Application of LMPSF Acquisitions, LLC c/o Troutman Pepper Locke, LLP to rezone property from C-2 (General Commercial) zoning district to HR-1 (High Density Residential – 1) zoning district to allow for single-family, attached and multi-family developments, at 3265 Northeast Expressway.

PETITION NO: D2-2025-0628 Z-25-1247529

Site Plan Review (*Illustrative Site Plan - Everstead at Embry Hills, dated 10/17/25*):

DEKALB COUNTY, GEORGIA
ILLUSTRATIVE SITE PLAN | DATE 10/17/2025

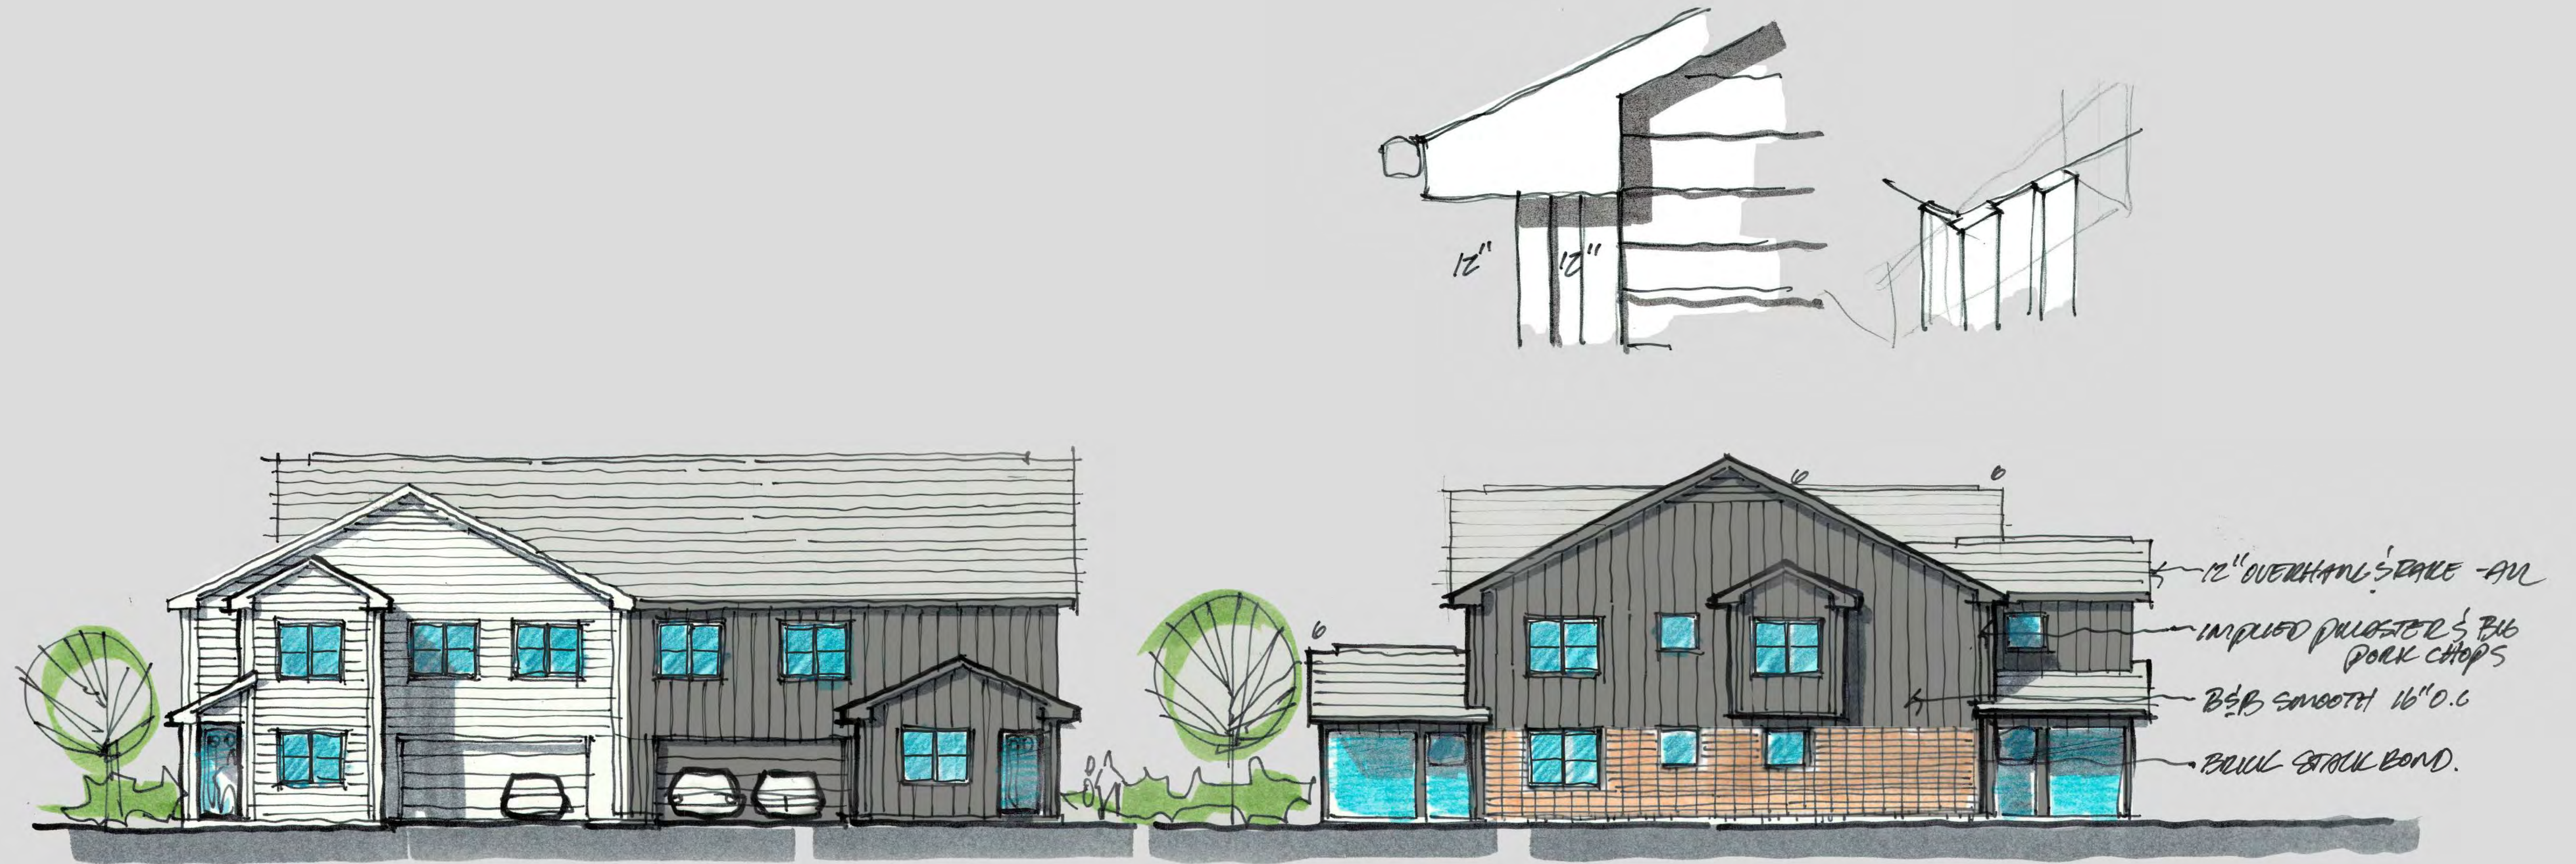
The site plan appears to comply with most of Section 27-2.11.2 – *Dimensional Requirements* for HR-1. However, because of the following deficiencies, variances may need to be sought:

- **Interior strips:** Interior to non-residential, mixed-use and multi-family developments, a three-foot (3) wide planted landscape strips shall be required along all interior drives and pedestrian paths per *Section 5.4.4 - Site and Parking Area Landscaping B*. As well as *D. Parking Area Landscaping tree and island quantity (4 and 5)*.
